TO: District of Columbia Zoning Commission

DATE: August 31, 2020

SUBJECT: Final Report on Zoning Commission Case No. 20-06 – Consolidated and Preliminary Planned Unit Development with Related Map Amendment at 1333 M Street, S.E.

Figure 1. Consolidated and 1st Stage PUDs.

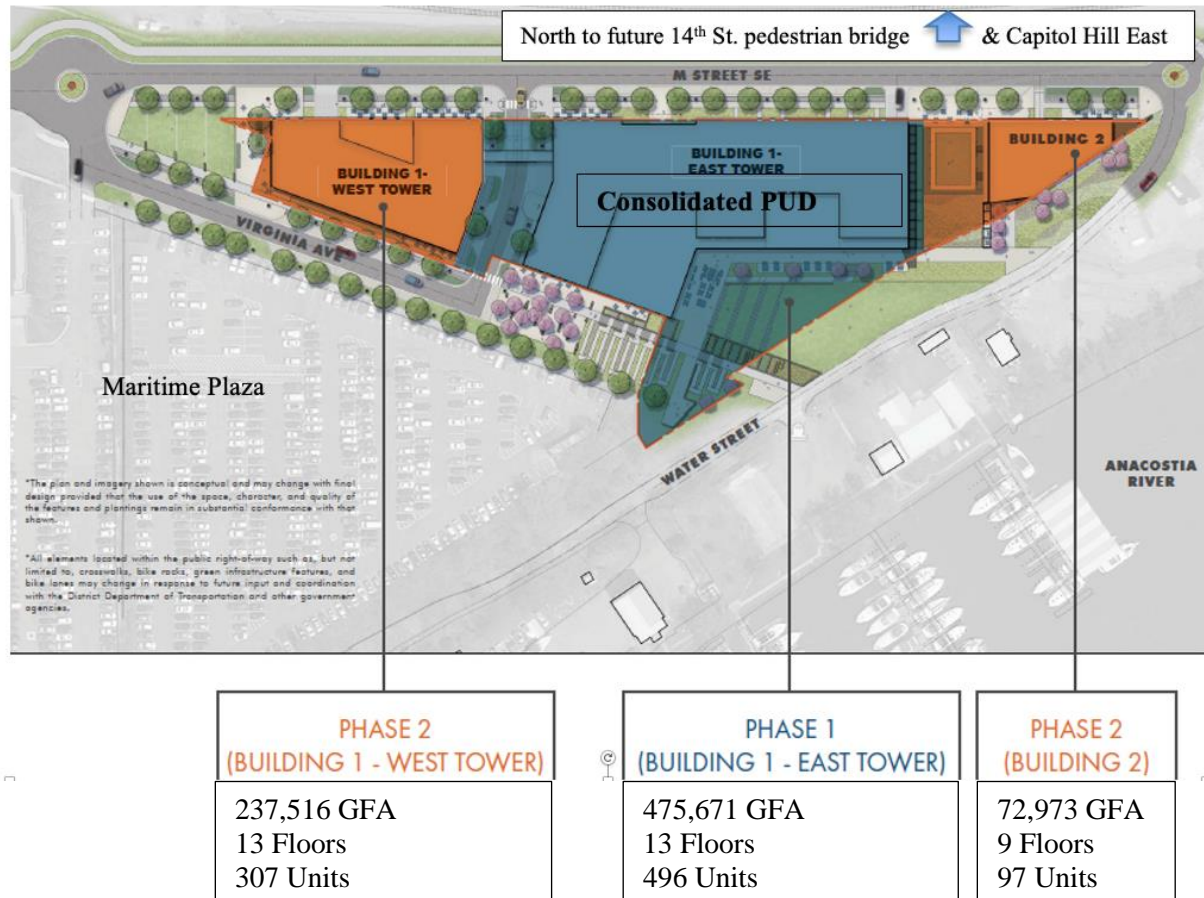
The Consolidated (PUD) would include what is labelled in Figure 1, above, as Building 1, East Tower (Tower 1E), and a 174-space parking garage below both Building 1E and 1st Stage PUD Building 1, West Tower (Tower 1W), and infrastructure and landscape improvements detailed below. The 475,671 square foot, 130-foot-tall structure would include:

Figure 5. Consolidated PUD

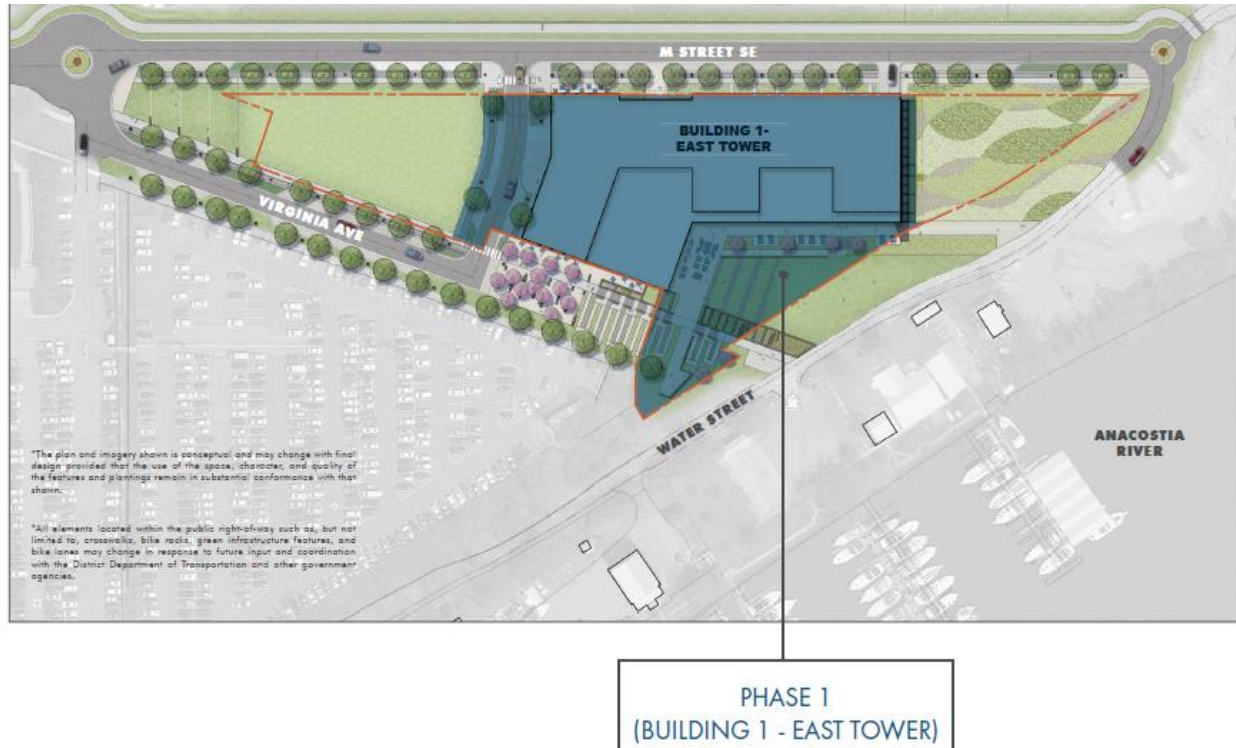
The architecture of the Consolidated PUD Tower 1E provides a variety of façade treatments. The western section and the portion of the retail base facing the river use red brick to respond to both the brick industrial buildings at the nearby Navy Yard and to traditional Capitol Hill facades with their masonry construction and punched windows. The eastern section, starting at the M Street level, is more modernist, with extensive use of glass. It also contains a large mid-level opening to provide visual connectivity with the waterfront from the north.

Since setdown the design has been simplified. This has better integrated the differences between the traditional and modernist facades and has provided a clearer line-of-site through the mid-level opening. More balconies have been added. The applicant has clarified that the pedestrian

In addition to the above information, the applicant should supply the following by the hearing:

- *Guidelines for any murals that might be visible from public ways (See Exhibit 30A2, Sheet A-3-2);*
- *Provide the square footage of the proposed green roof.*
